Commission Briefing on License Renewal Guidance Documents

License Renewal Guidance Documents

SUBJECT: COMMENTS ON GENERIC AGING LESSONS LEARNED (GALL) REPORT

Figure 1

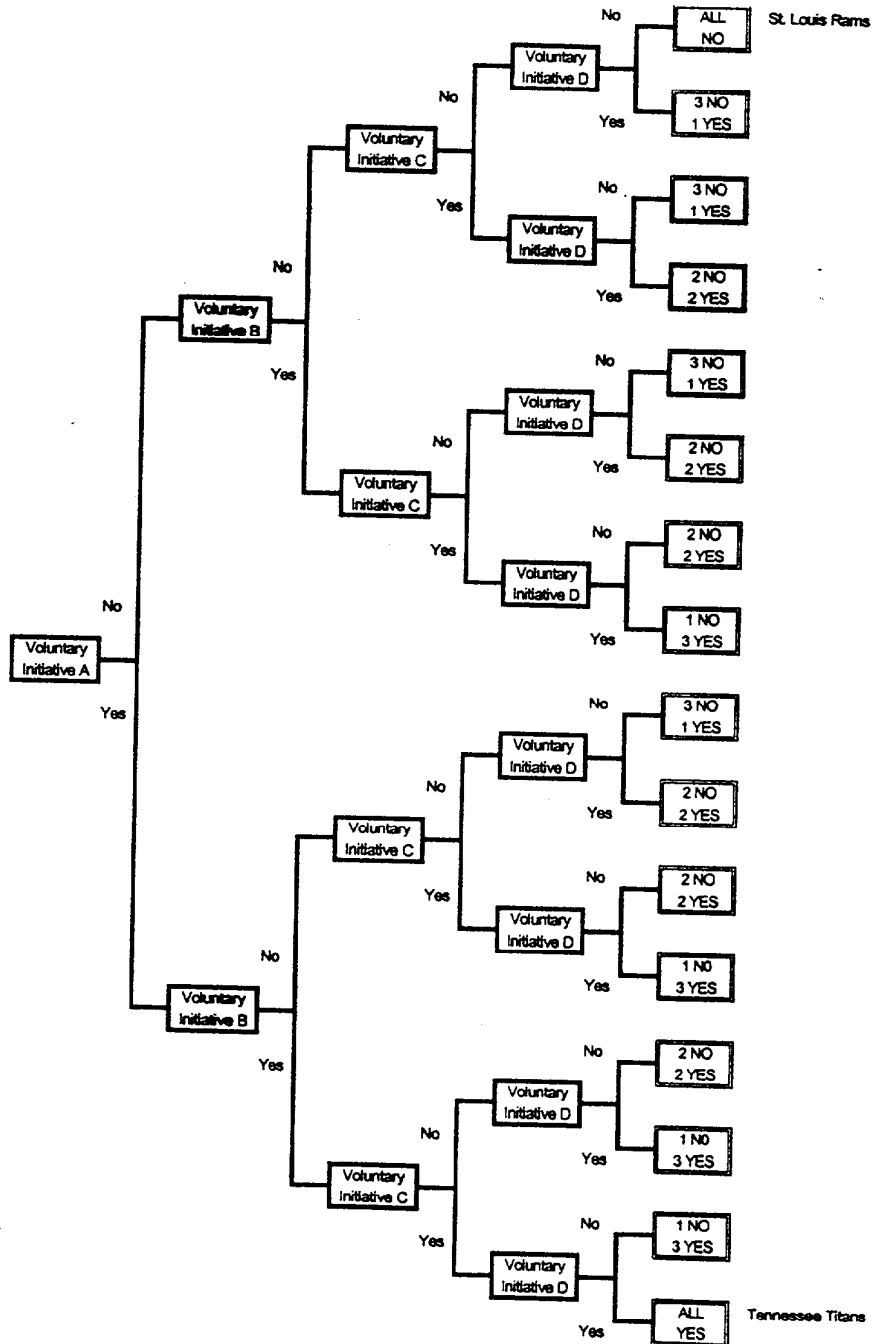
Because the voluntary regulatory initiatives are not mandatory, it is reasonable to assume that some plant owners will adopt all of the initiatives, some plant owners will adopt none, and some plant owners will adopt some of them. Figure 1 illustrates the potential dilemma for just four (4) voluntary regulatory initiatives. If the plant owners will be equally divided on every decision, sixteen (16) distinct regulatory schemes are produced. The real problem is even more mind-boggling because the agency is considering more than four (4) voluntary initiatives and plant owners also have the option of adopting them in any order (e.g., A-B-C-D, D-A-C, A-C-D, D-A-C-B, etc.).

Figure 1 also illustrates a specific concern about the intended use of the GALL report. That concern relates to the fidelity of all the voluntary regulatory initiatives. In other words, are all of the initiatives compatible and interchangeable? I attended the public workshop on GALL conducted by the NRC staff on September 25, 2000. Pointing out that the draft GALL report differentiated between aging management program requirements for safety and non-safety related components, I asked Mr. Christopher Grimes about the impact of a plant owner who has adopted the voluntary special treatment requirements initiative. Mr. Grimes conceded that the GALL report might have to be revised to accommodate that case. The questions that the NRC should answer before issuing the final GALL report, or approving the adoption of any voluntary initiative, include:

1. Is the GALL report rendered obsolete or invalid when a plant owner adopts a voluntary regulatory initiative (such as risk-informed special treatment requirements) before submitting the license renewal application?
2. Is a license renewal granted based upon the GALL report invalidated when that plant owner subsequently adopts a voluntary regulatory initiative?
3. Is the regulatory endpoint for a plant adopting voluntary initiative X before submitting a GALL-based license renewal application equivalent to that for a plant submitting a GALL-based license renewal application before adopting voluntary initiative X?
4. When the voluntary regulatory initiatives spawn a spectrum of regulatory schemes, as suggested by Figure 1, what does Generic mean?

In summary, UCS recommends that the issuance of the GALL report be deferred until after the NRC staff concludes a formal evaluation of how it is affected by the various voluntary initiatives being pursued. After all applicable changes to the GALL report resulting from that evaluation have been incorporated, another public comment period of at least 60 days should be opened for the updated draft GALL report.
